SERVICE INSTRUCTION

Oil Pressure Sensors for ROTAX® Engine Type 912 and 914 Series

ATA System: 79-20-00 Oil pump assy.

10330

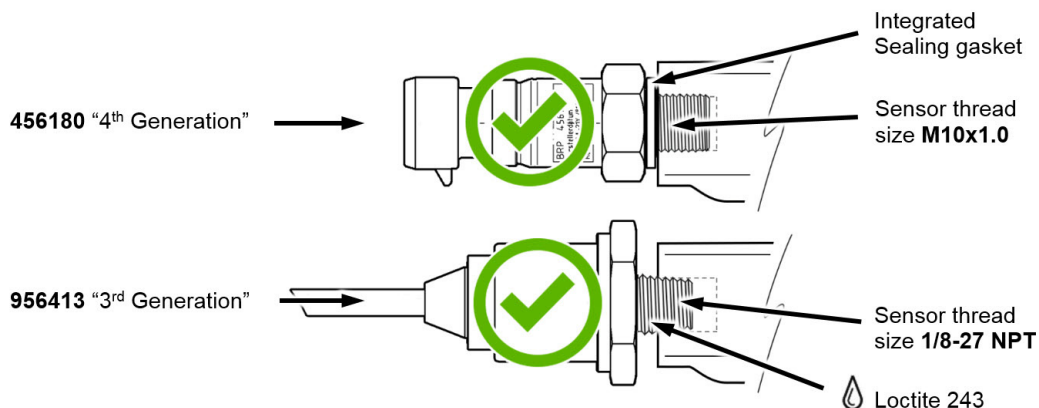
Oil pump housings part no. 911810 and part no. 911815 are supplied with M10x1.0 oil pressure sensor attachment threads.

New oil pressure sensor part no. 456180 has matching M10x1.0 attachment threads.

Step	Procedure
1	Install sensor part no. 854180 with LOCTITE 243. Tightening torque 15 Nm (132 in.lb).

10331

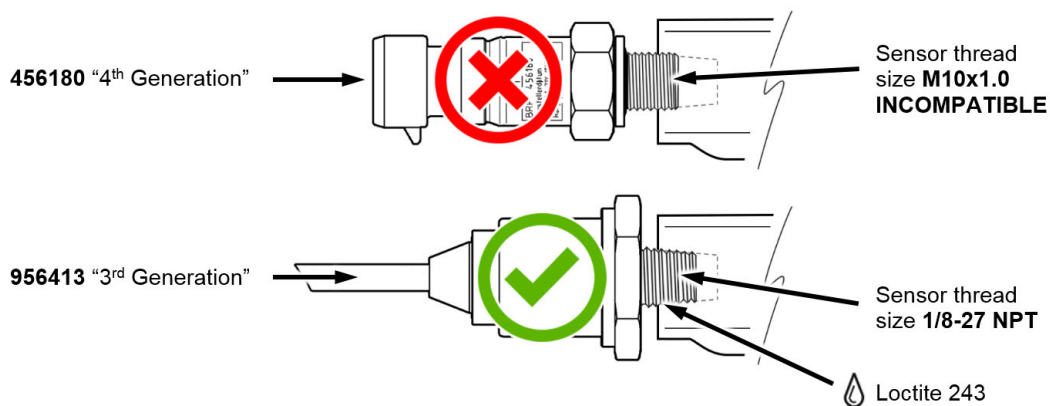
New oil pressure sensor part no. 456180 cannot be installed with oil pump housing part no. 911809. Oil pump housing must be replaced, or the threads must be reworked.

Step	Procedure
1	Remove the oil pump housing in accordance with the relevant Maintenance Manual (Heavy).
2	Replace oil pump housing with part no. 911815 in accordance with the relevant Maintenance Manual (Heavy).
3	Install sensor part no. 456180 with LOCTITE 243. Tightening torque 15 Nm (132 in.lb).

Step	Procedure
1	Remove the oil pump housing in accordance with the relevant Maintenance Manual (Heavy).
2	Rework pressure sender attachment threads with M10x1 thread tap.

Step	Procedure
3	Install the reworked oil pump housing in accordance with the relevant Maintenance Manual (Heavy).
4	Install sensor part no. 456180 with LOCTITE 243. Tightening torque 15 Nm (132 in.lb).

Fig. 5

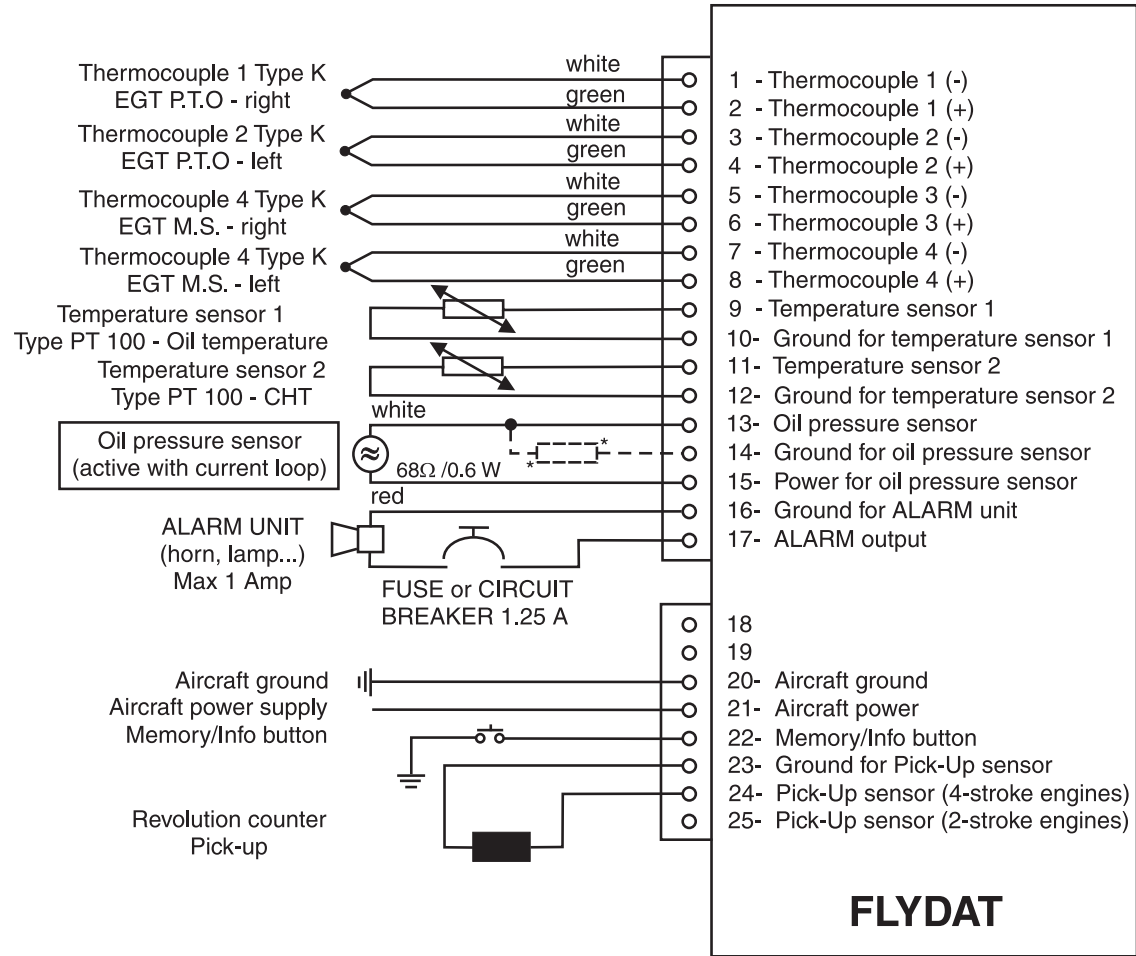
* resistor is part of the retrofit kit for Flydat part no. 886857. See also 1.3.2.
